Memo No: 27.29.0000.012.07.015.21-420

Sub: Minutes of the Pre-Tender Meeting and 1st Amendment of Tender Document on Ref. No. 27.29.0000.012.07.015.21-255 Issued on 10.02.2021 for Procurement of “Design, Supply, Erection, Installation, Testing and Commissioning of Upgradation of Shibbati, Shantahar, Rahmannagar, Nurpur, Bahirgola and Raypur, 33/11 KV Substation on Turnkey Basis under Rajshahi Power Distribution Development Project (ICT)”.

DRAWING OF 33 KV T-TYPE CONNECTOR (36/25 mm)

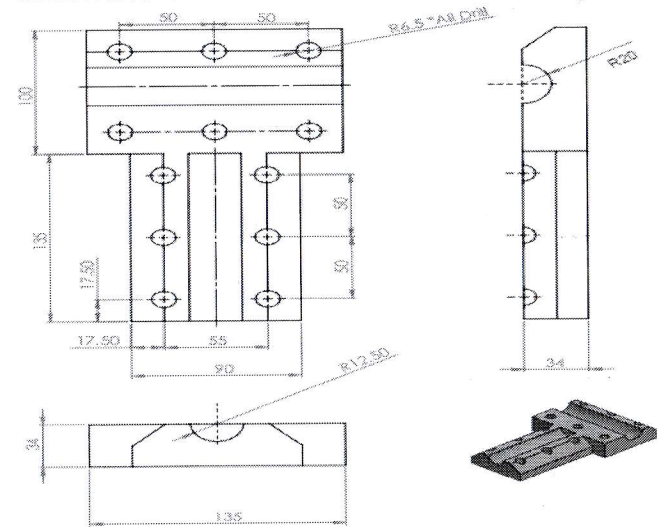
Current density at the minimum cross Section of a) Moving Blade b) Terminal Pad c) Contacts d) Terminal Connector	Amps/Sq.mm	To be mentioned																													
Maximum Temp. rise of current carrying parts when carrying rated current continuously (deg. C)	deg. C	To be mentioned																													
13	Section 8 - GTP of connectors: 8.03 [Row No:76]	Internal Arc Classification IAC A FLR- 31.5 KA for 1 sec	Internal Arc Classification IAC A FLR- 31.5 KA for 1 sec (Must be supported by type test report from any short-circuit testing liaison (STL) Member [http://www.stl-liaison.org/web/03_Members.php] Testing Organization or Laboratory as per relevant IEC standard).																												
14	Section 8 - GTP of connectors: 8.38 (Newly Added)	-	<p>GTP & Drawing of all the required connectors has to be provided. Here for example; GTP & Drawing of T-TYPE CONNECTOR (36/25 mm) has been provided. Few other connectors are - 33 KV FLAT I-TYPE CONNECTOR (25 mm), 33 KV Double I-TYPE CONNECTOR (25/25 mm), 33 KV Double I-TYPE CONNECTOR (36/25 mm), PG Clamp (ACSR Grosbeak) etc. If any other type connectors are to be used, then GTP & Drawing of the same items must be provided. Dimensions of all the connectors have to be similar to the attached drawing here. Dimensions of connectors are subject to approval from NESCO.</p> <p>GUARANTEED TECHNICAL PARTICULARS (GTP) FOR 33 KV T-TYPE CONNECTOR (36/25 mm)</p> <table border="1"> <thead> <tr> <th>Sl. No.</th> <th>Description</th> <th>NESCO's Requirement</th> <th>Manufacturer's Particulars</th> </tr> </thead> <tbody> <tr> <td colspan="4">Compatible for ACSR MARTIN to ACSR GROSBK</td> </tr> <tr> <td>1.</td> <td>Name & Address of the Manufacturer</td> <td>Shall be mentioned</td> <td></td> </tr> <tr> <td>2.</td> <td>Manufacturer's Code No.</td> <td>Shall be mentioned</td> <td></td> </tr> <tr> <td>3.</td> <td>Applicable Standard</td> <td>BS, IEC, BDS or equivalent international standard</td> <td></td> </tr> <tr> <td>4.</td> <td>Installation</td> <td>Outdoor and shall be installed for the above-mentioned conductor.</td> <td></td> </tr> <tr> <td>5.</td> <td>Type</td> <td>Bolted Type</td> <td></td> </tr> </tbody> </table>	Sl. No.	Description	NESCO's Requirement	Manufacturer's Particulars	Compatible for ACSR MARTIN to ACSR GROSBK				1.	Name & Address of the Manufacturer	Shall be mentioned		2.	Manufacturer's Code No.	Shall be mentioned		3.	Applicable Standard	BS, IEC, BDS or equivalent international standard		4.	Installation	Outdoor and shall be installed for the above-mentioned conductor.		5.	Type	Bolted Type

SL No	Clause No & Name	Queries/Written as	Explanation/Amendment			
			6.	Material	Aluminium Alloy (LM6 or higher grade)	
			7.	Minimum continuous current rating at 35°C rise over 40°C ambient temperature (75°C)	Shall be mentioned and capable of carrying the continuous current of the specified conductor in Amps.	
			8.	All Dimensions, Dia and Hole Size	Shall be as per drawing (Drg. No. 7.2) (To be confirmed)	
			9.	Weight of 100 nos. in Kg	Shall be mentioned	
			10.	Dimensional Drawing	Shall be enclosed
